Flight Procedures Cover Page	Task Action: FLIGHT CHECK	Task Type: STAR	Estimated Chart Date: 12/02/2021	APWS Task ID: 5AEC4B5D4CA54541B2915F8A16A54383	APWS Project ID: EB4C6301500949BE9516AA4DDF3BCC38
Procedure: JAFAR TWO		Enroute: YES	Specialist: Fowler, Shane		Agreement Number:
Airport ID: KMCO			Airport City: ORLANDO		State: FL
Facility ID:	Facility Type:	Flight Inspection Remark Type: New FC Slot			
<p>Procedure Comments: CONTACT: ALLAN WILL 405-954-6103.</p> <p>09/28/2021: THIS IS A CORRECTED COPY OF THE FORM APPROVED ON 07/12/2021. 1. REMOVED NOTE: Descend via MACH number until intercepting 280 KIAS. Maintain 280 KIAS until slowed by the STAR or assigned by ATC.</p> <p>08/03/2021</p>

FIPC BASIC FORM								
PROCEDURE: JAFAR TWO			AIRPORT NAME: ORLANDO INTL		AIRPORT ID: KMCO	SPECIAL CONTROL NO: AP-08-171-21		
FAC ID: JAFAR2		CITY: ORLANDO			ST: FL	ORIG CHART DATE: 12/02/2021		
DFL TYPE: PROC/T	THIRD PARTY: <input type="checkbox"/> YES	EST. TIME ON SITE: 0.4	REIMB. NUMBER:		PTS TASK ID:			
PREFLIGHT NOTES								
REVIEWER:					DATE:			
COMMENTS:					CHECK ONE: <input type="checkbox"/> FLT CK REQ <input type="checkbox"/> NFCR <input type="checkbox"/> REJECT			
							YES	NO

JAFAR TWO ARRIVAL (RNAV)
(JAFAR.JAFAR2) FIG

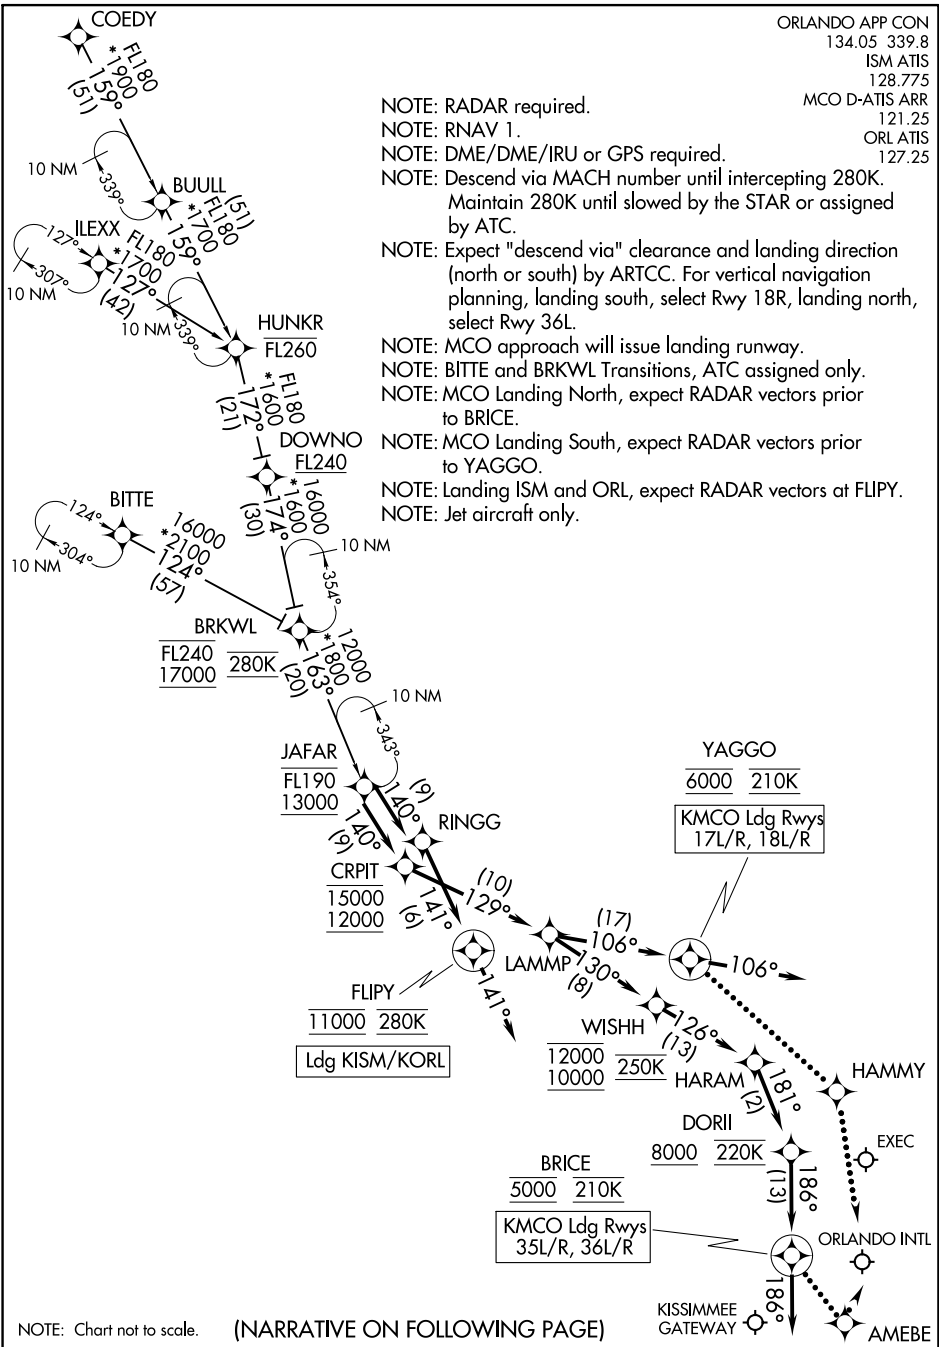
FLIGHT INSPECTOR REMARKS: Moved FLIPY and changed from RINGG and FM course after FLIPY. Part of FL METROPLEX DFL Stmt – Procedure Satisfactory for GNSS operations, DME/DME awaiting approval by the applicable AJV Operations Support Group.								
IN-FLIGHT OBSTACLE REPORT								
OBSTRUCTION ID #:	COORDINATES OR LOCATION:	GNSS ALTITUDE (MSL):	BAROMETRIC ALTITUDE (MSL):		HEIGHT ABOVE GROUND LEVEL:

LANDING KISM/KORL: From JAFAR on track 140° to RINGG, then on track 144° to cross FLIPY at 11000 and at 250K, then on track 144°. Expect RADAR vectors to final approach course.
